Our Ref: 240332

**RE: DA/2023/415 RESPONSE TO REQUEST FOR INFORMATION  
WYNDELLA ROAD, LOCHINVAR**

**258 Lot Subdivision including 2 public reserves, 1 drainage reserve, road widening and associated infrastructure over 14 stages.**

**Figure 1: Proposed Parking Restricted Areas on Roads MC12 – 16, based on Figure 10 of Updated BAR**

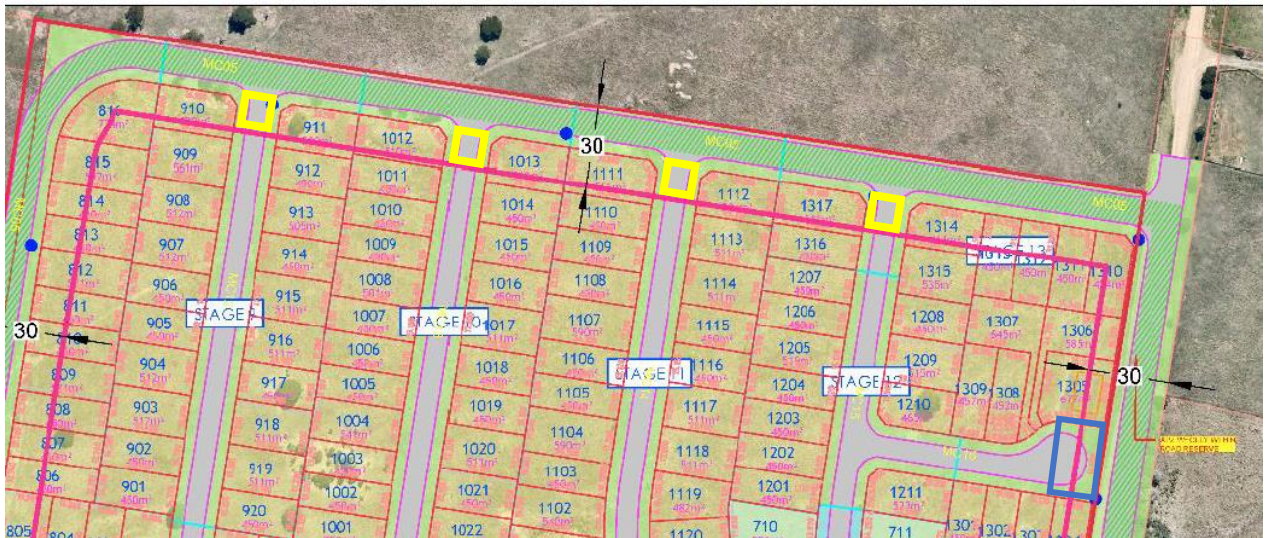
- On-street parking would be restricted directly at the front of Lots 910, 911, 1012, 1013, 1111, 1112, 1314 and 1317, as these lots front internal roads. The yellow outline on **Figure 1** below identifies the short extent of road with parking restrictions. However, ample on-street parking is provided along the secondary frontages of these lots by virtue of the perimeter road (MC05), with limited to no 'competition' given only four lots front Road MC05 directly at the eastern end.

- A short extent of the cul-de-sac head (MC16) would be subject to no-parking a result of this Performance Based solution (outlined in blue on Figure 1 below). This coincides with other no-parking restrictions discussed in Section 3.2.5 of this letter for other reasons, and as a result, it is not considered a significant impact to parking.

- As can be seen on **Figure 2** overleaf, parking will be restricted for approximately 30m along Road MC04, essentially at the primary frontage of Lot 217 and 218 (refer to blue outline). Notwithstanding, on-street parking is available along the secondary frontage of Lot 218, noting that this part of MC04 is a perimeter road with parking provided on the lot side and directly north of Lot 217 on both sides of the road. In this regard, the short extent of restricted parking is considered reasonable.

- Parking will also be restricted on proposed Road MC09 where it runs parallel with Wyndella Road, as outlined in blue on **Figure 3**. This outcome is considered reasonable, given it coincides with the secondary boundaries of Lots 610 and 611.

**Figure 4: Lots affected by PMF Flood Extent  
(ADW Johnson, Dwg. 240332-ESK-009-C, 27 June 2024)**

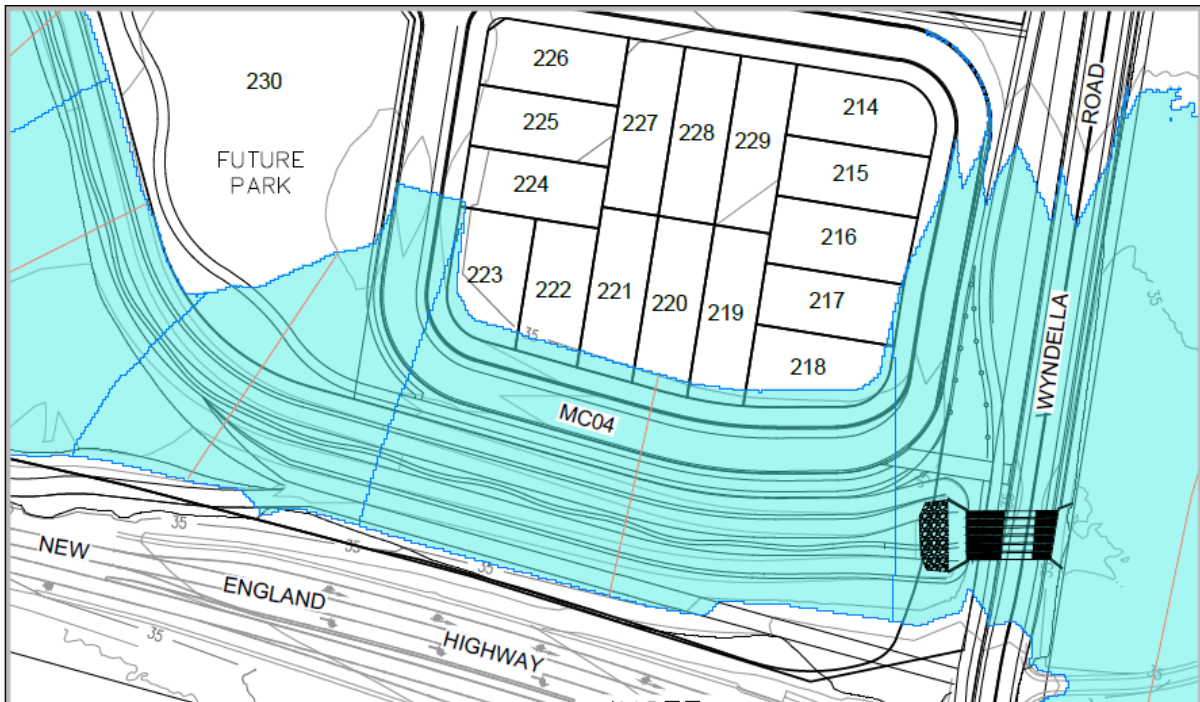
The proposed layout has been amended and no longer proposes Lots 206 and 1010 in their previous form. In this regard, Council's comments relating to flood-free access in this context are no longer relevant. Further, the proposal no longer includes residential lots with a direct interface to the riparian corridor and therefore the requested cross-section is no longer required.

Having regard to the revised layout, we confirm that all lots are flood free for all design events up to and including the PMF, with the exception of several batters within the 5m front setback of some lots (shown in **Figure 4** below). This confirms that refuge-in-place is appropriate for the proposed development in extreme flood events. Further details are provided in the updated Stormwater Management Plan (**Attachment 13**).

- The local park has an area of 5,102m<sup>2</sup>;
- A small portion of the local park is liable to the PMF (refer to **Figure 4** above); however, it is entirely flood free in the 1% AEP, which is considered a reasonable outcome;

Figure 5: Lochinvar URA Area Plan (Figure 55 of MDCP Section F.9)

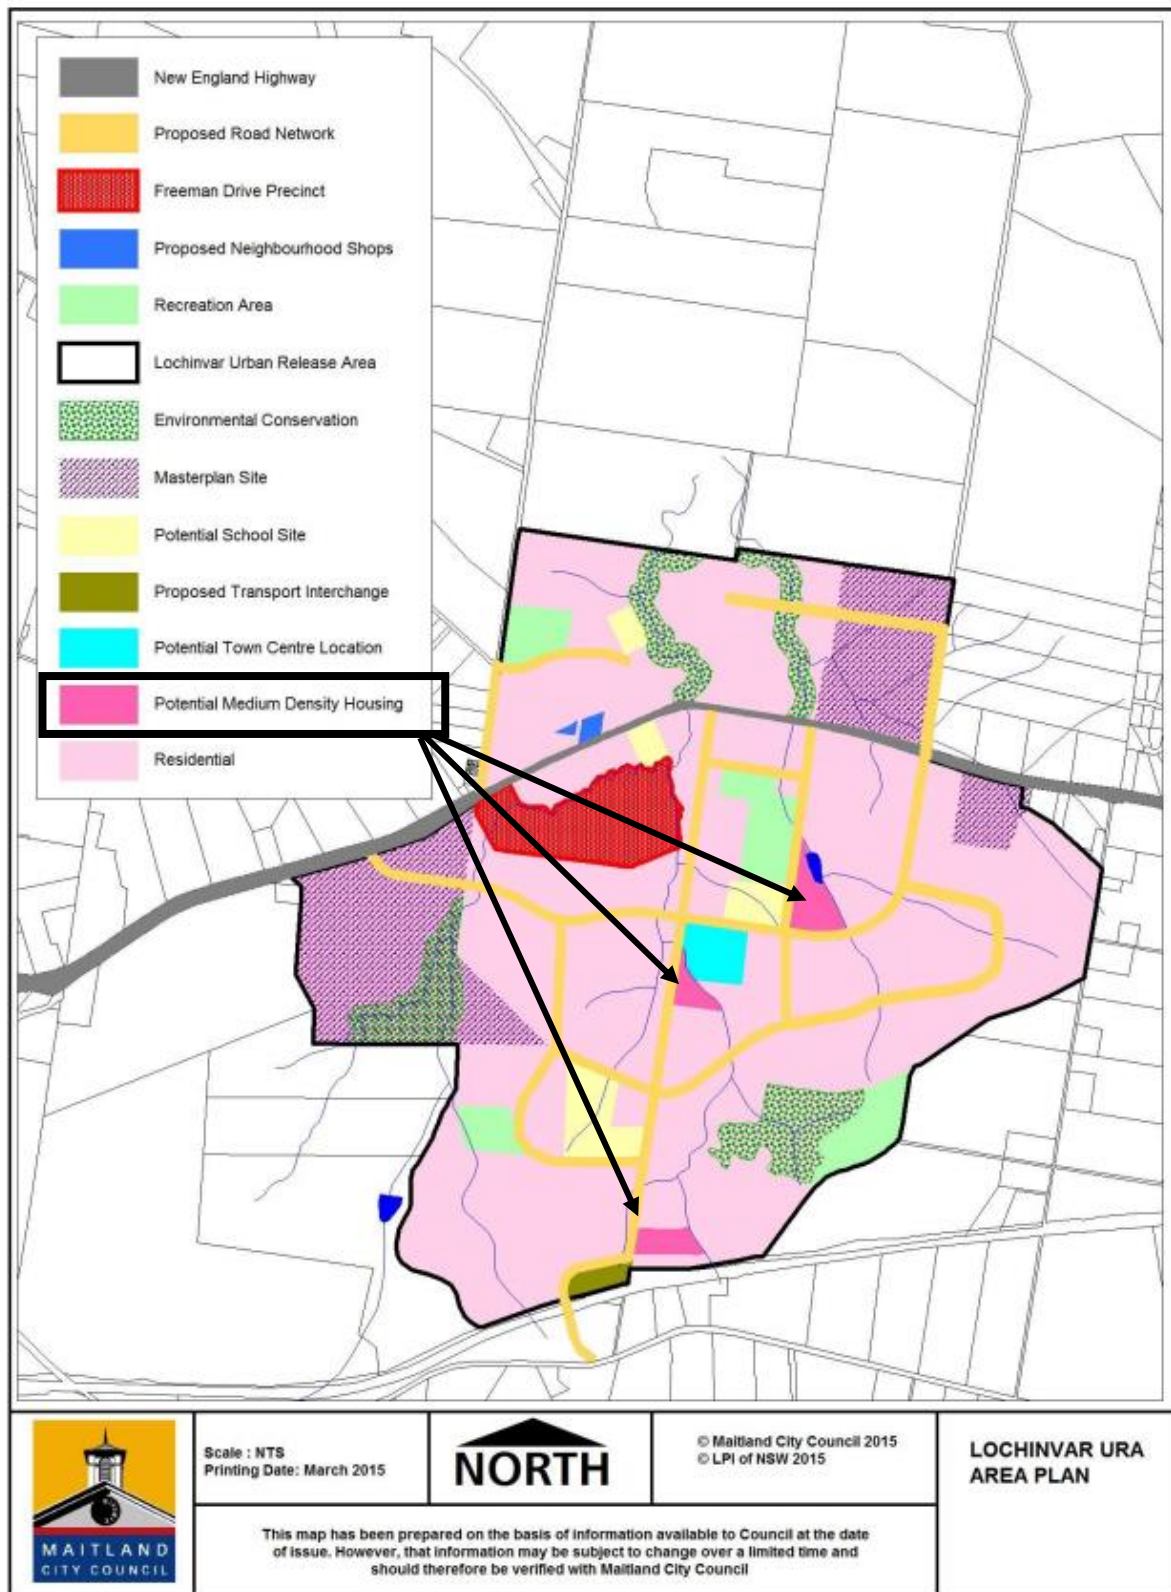
- In terms of access to future facilities, reference is made to Figure 55 of LURA which provides the overall area plan, identifying various land uses across the URA. Although it is acknowledged that this is a strategic document and may be considered as somewhat indicative, there is a clear intention to provide key services and facilities to support the URA south of NEH. This includes the future town centre, recreation areas, potential school sites and the proposed transport interchange accessing the railway line.

- In addition to this, and perhaps most relevantly, Council has specifically identified locations for 'potential medium density housing' on Figure 55. Consistent with the point made above, these are all focused south of NEH and adjacent to key facilities and services.

**Figure 6: Cross Section of Fencing with adjoining School Land**

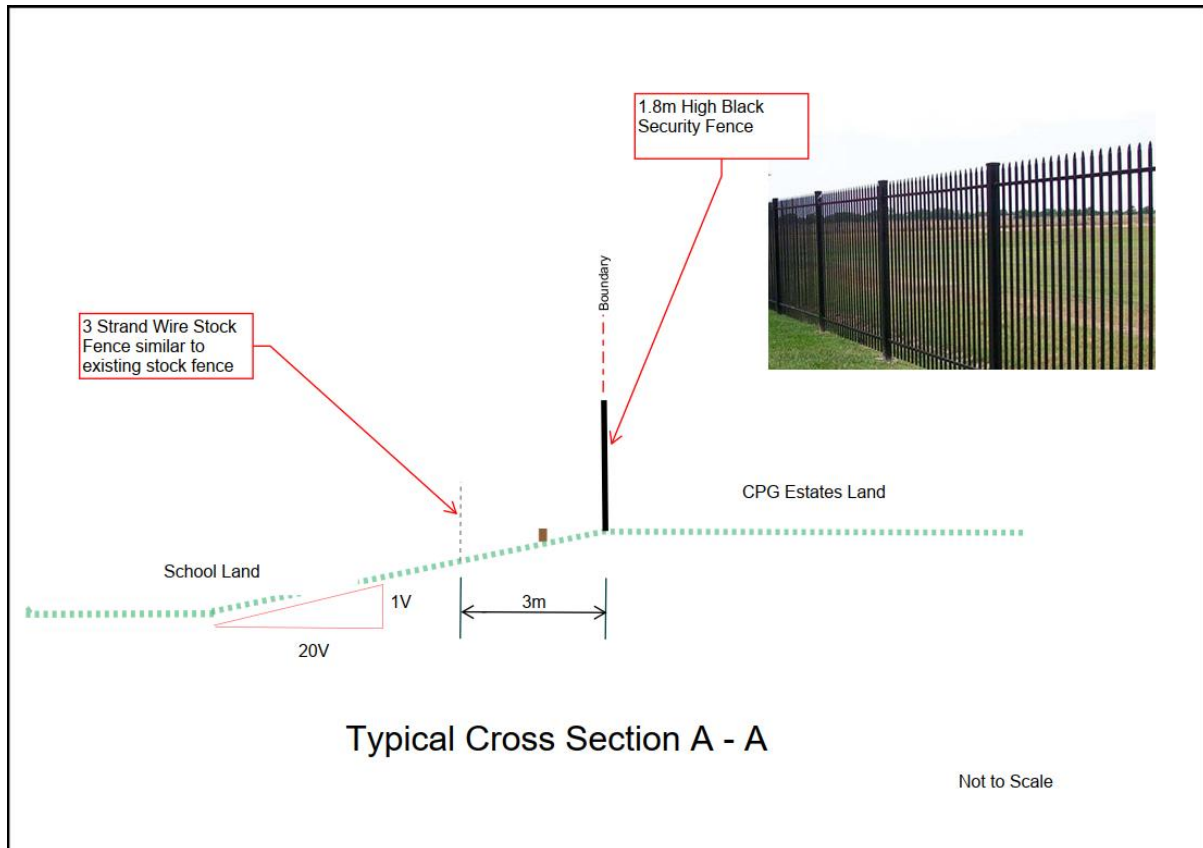
Council has requested 'rural style' fencing for the northern boundary of the RU1 land, and details of proposed fencing between the residential subdivision and the residue land to the west of the perimeter road. The requirement to provide fencing along these interfaces as part of the DA is not considered necessary on the basis that perimeter road frontage will be provided, providing a legal and physical separation between developed and undeveloped lands, and fencing arrangements should be an agreement between neighbours.

- Stock fencing (three strand wire) will be installed along the northern boundary as the land is currently used for agricultural purposes, and this is a requirement of the adjoining owner and leasing conditions;
- Security fencing will be installed along the shared boundary with the school, as per a separate agreement with the adjoining owner (refer to **Figure 6** below); and
- For the portion of land to the west that does not form a boundary with the school, this is a shared road centred on the common boundary and any fencing in this location is not accepted by the adjoining owner.
